# ADDENDUM TO: PARK PLACE VILLAGE (PHASE 2) URBAN DESIGN BRIEF

For Proposed "TOWN CENTRE" Development WATERDOWN, CITY OF HAMILTON

TOWN CENTRE
Proposed Development
609 and 615 Hamilton St. N.,
3 Nisbet Blvd. and
129-137 Truedell Dr.
City of Hamilton

January 28, 2019 Ref. No.: S-2269

Conceptual Design Vision For "Town Centre"

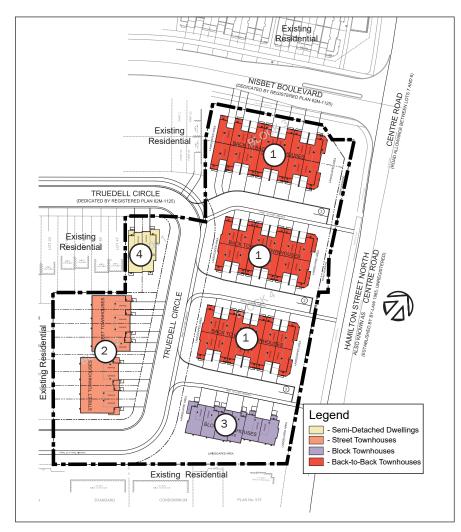
Update Section 1.3 - Update Conceptual Design Vision diagram (page 5).

Proposed "Town Centre" Subdivision Plan

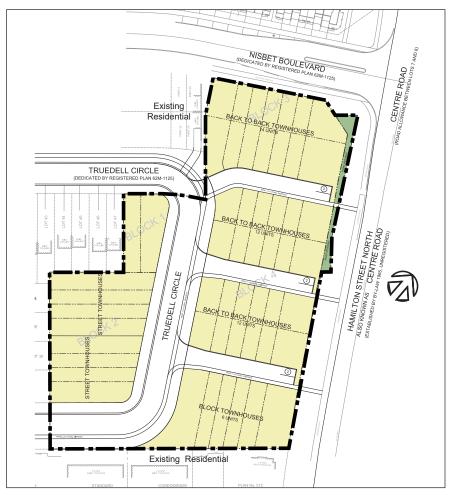
Update Section 1.4 - Planning Context and diagrams (page 6).

• The proposed development respects the 'Community Vision' criteria and 'Design Objections' in sections 1.2 and 1.3 of the Waterdown North Urban Design Guidelines. The proposed Development Plan for "Town Centre" will provide urban design features and built form that will have a positive impact on the image and character of the Waterdown North Community and maintain the intent of the Waterdown North Secondary Plan.

Structuring Elements Plan

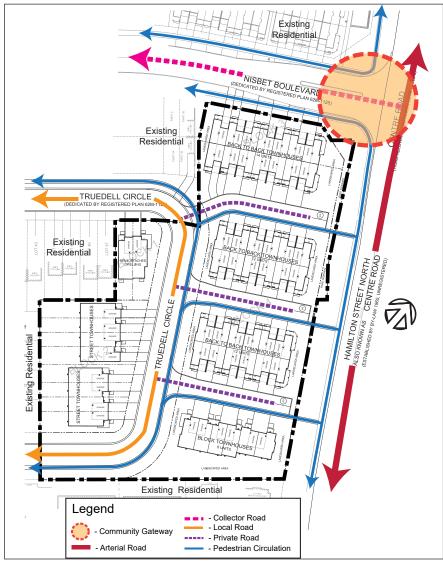
Update Section 2.1 - Structuring Elements Plan diagram (page 7).

**Built Form Distribution Plan**

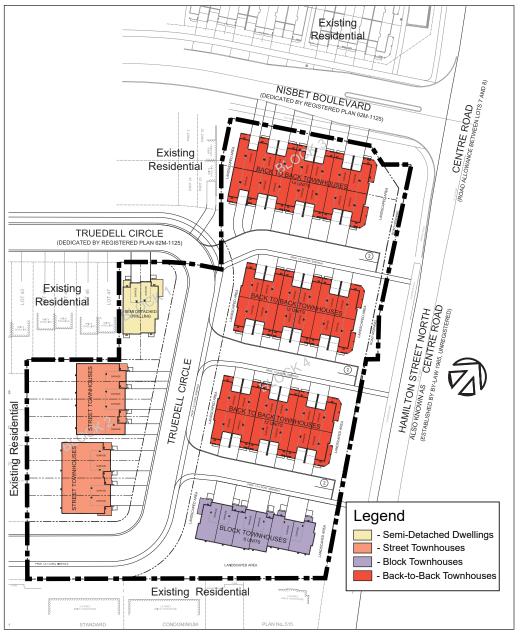
Update Section 3.2 - Built Form Typology and diagram (page 14)

Town Centre will have a variety of residential building types and may include:

- semi-detached dwellings;
- street townhouses;
- block townhouses;
- back-to-back townhouses.

Priority Lot Map - "Town Centre"

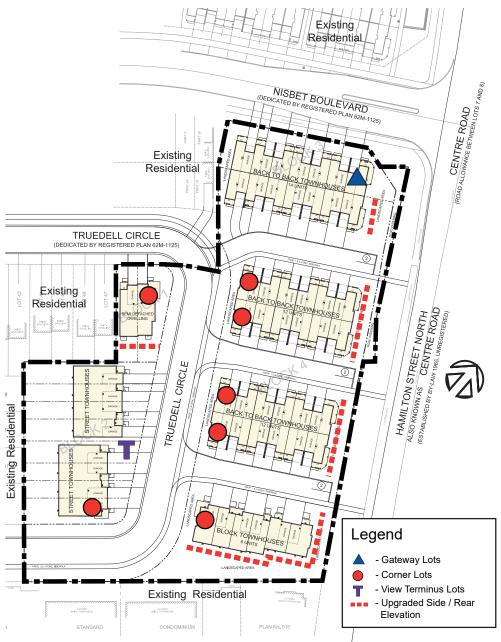
Add new Priority Lot Plan (page 26).

Design criteria required for priority lots as shown on the Priority Lot Map (i.e. gateway lots, corner lots, side / rear upgrade lots, view terminus lots) is contained in section 3.2 of the Waterdown North Urban Design Guidelines.
